CONFIGURATION CHANGE

REQUEST NOTICE

TITLE ELEMENTARY DIAGRAM
SEAL WATER TO
VOLUME CONTROL TANK

SONGS I
 SAFETY RELATED
 SOLENOID VALVE

AFTER
 Drwg. # 455437-3
 CGN # 4
 Sheet # 2 of 2

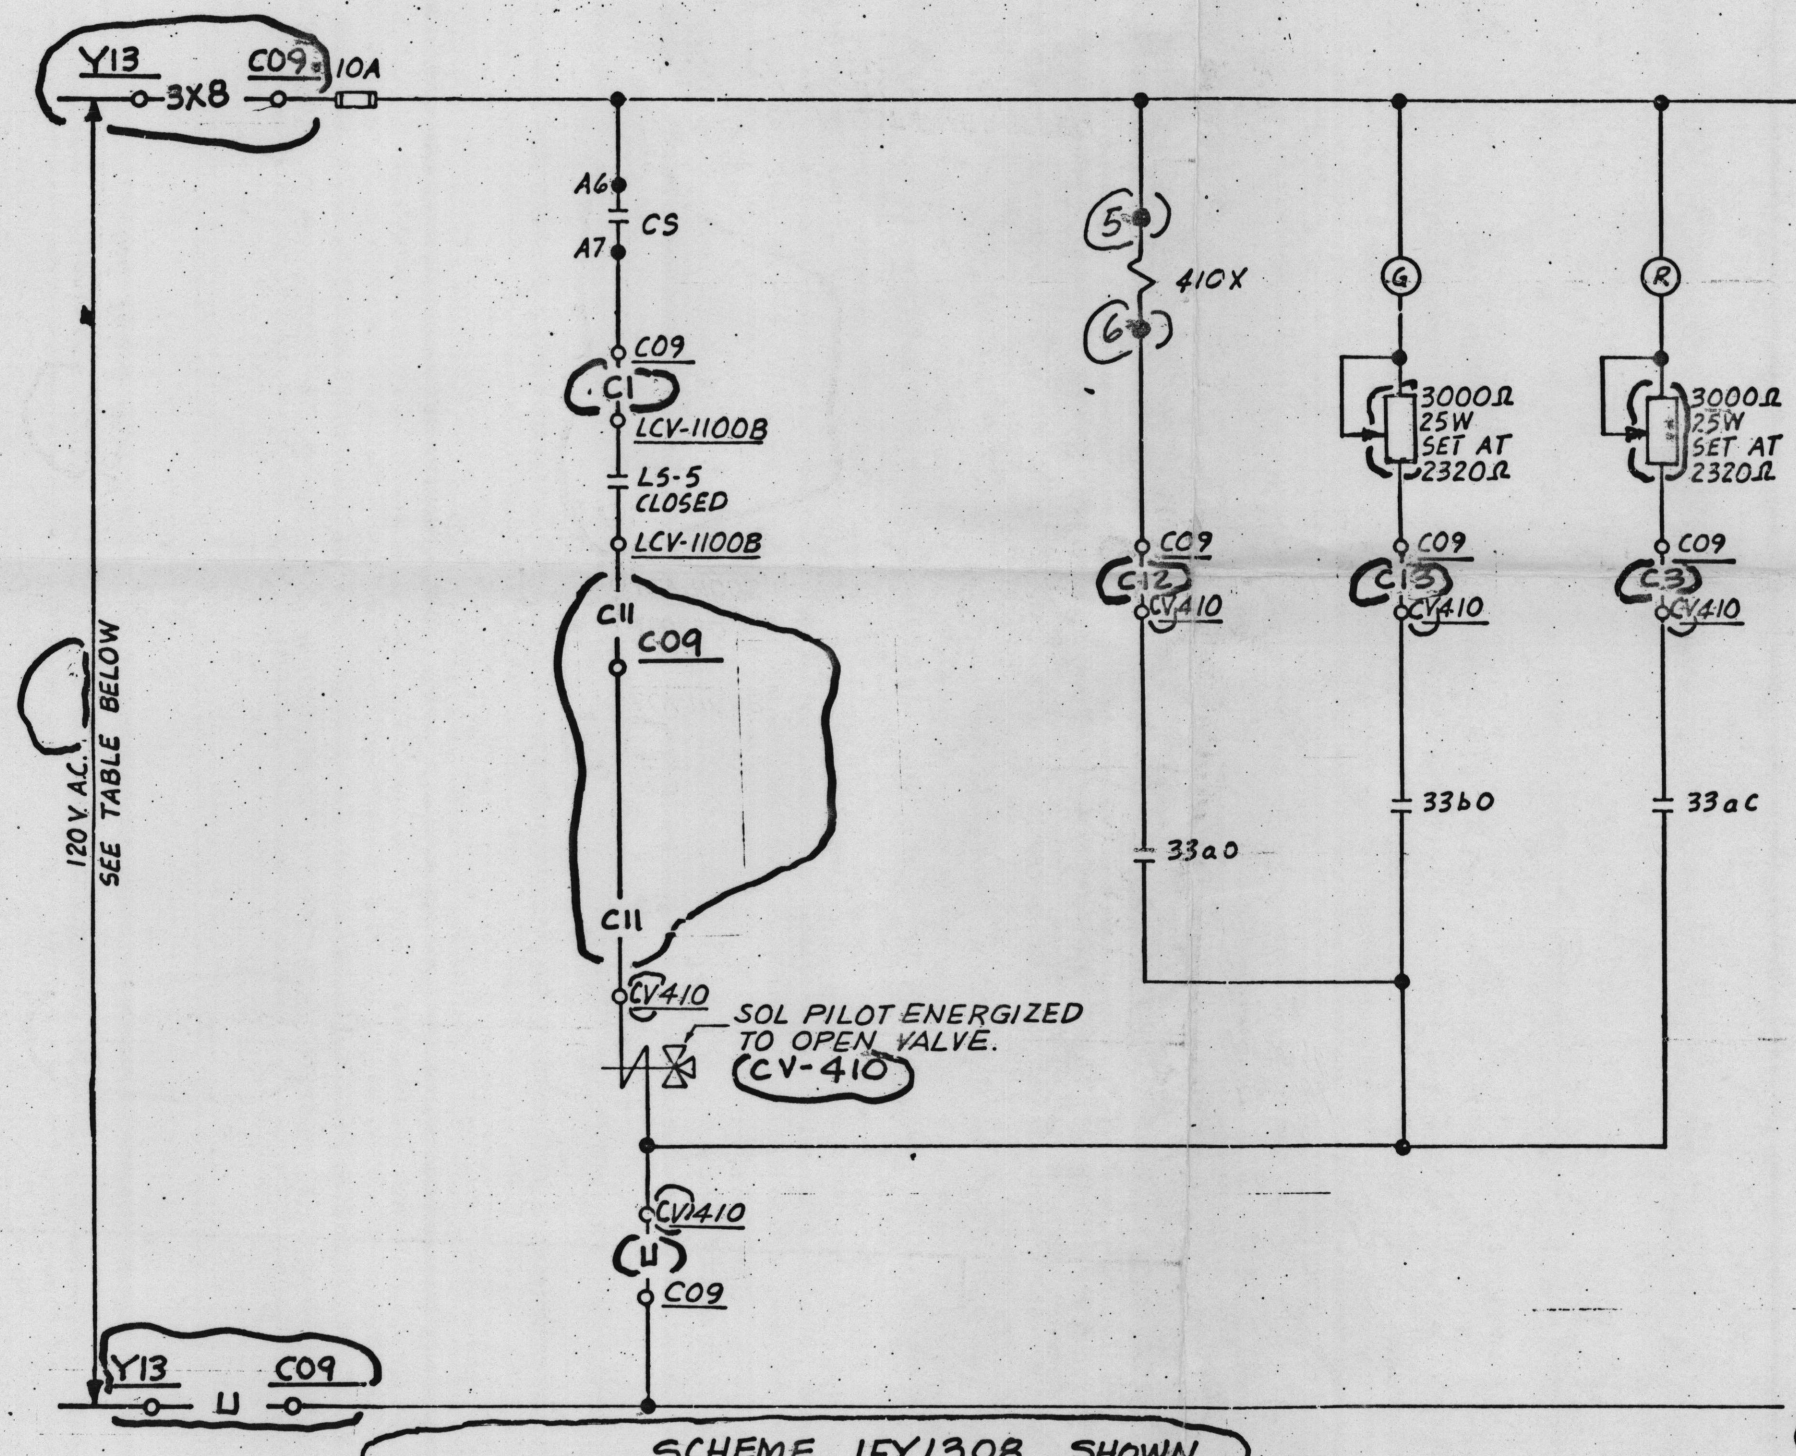
1. ADDED LOC. NOS. Y13, Y14 & C09; ADDED "CS" TO CONTROL SWITCH
 2. ADDED WIRE NOS. 3X8 & U; CHANGED RELAY 410Y TO 410X; ADDED NOTE "EXCESS LETDOWN SEALWATER HT. EX. STOP CV-412" TO CONTACT 2-B OF 410X
 3. DELETED CONTACT LS-5 OF MOV-LCV-1100D & CONTACT 1-3 OF RELAY 411X
 4. REPLACED WIRE NOS. 410S2, 410S1, 410N, 410X, 410RG & 410RR WITH C1, C11, U, C12, C13 & C3 RESP.
 5. ADDED REF. DWGS. 5154354, 233843 & 233844.
 6. ADDED DEVICES "410X, 411X, CS(HS-410) & CS(HS-411); BKCR. "8-1308, DWG. 5130359" SCHEME NOS. 1FY1308 & 1GY1402 & LOC. NOS. Y13 & Y14 TO EQUIPMENT TABLE. DELETED INTERLOCKS LCV-1100D(LS-5) & LCV-1100E(LS-6)
- OTHER AFFECTED DWGS: 233843, 233844.
EFFECTIVITY DATE: IMMEDIATELY
